# Access Compliance Report

## Public Rights-of-Way

### (Curb Ramps)

| Intersection ID: 23171 | Main Street: CAMILLA_DR | Cross Street: MORROWICK_RD | Location: NE           |

| ADA ID: 232D22BF722E   | Ramp Type: PerpDiag     | Initial Pass/Fail: Fail    | Overall Compliance: No |

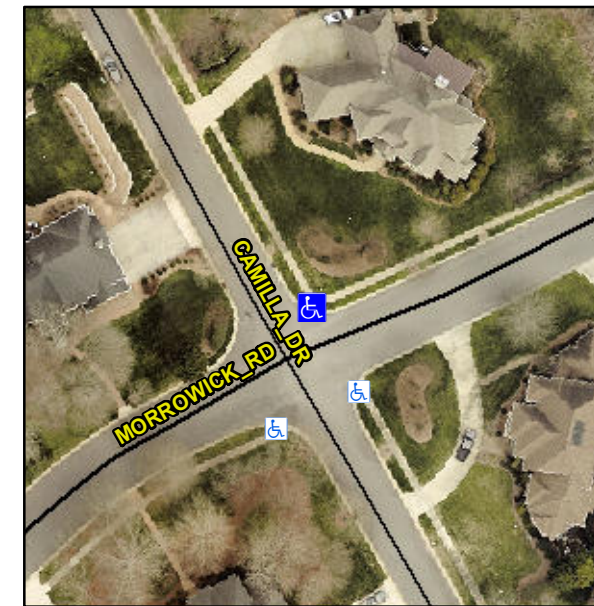
**Not Found, R304.5.1, R304.5.3**

| Compliance | Description           | Data | Compliance | Description                 | Data  |
|------------|-----------------------|------|------------|-----------------------------|-------|
| No         | Ramp Width (in)       | 24.0 | No         | Ramp XSlope (%)             | 7.2   |

**Remove & Replace Curb Ramp With Two New Directional Ramps or Equivalent.**
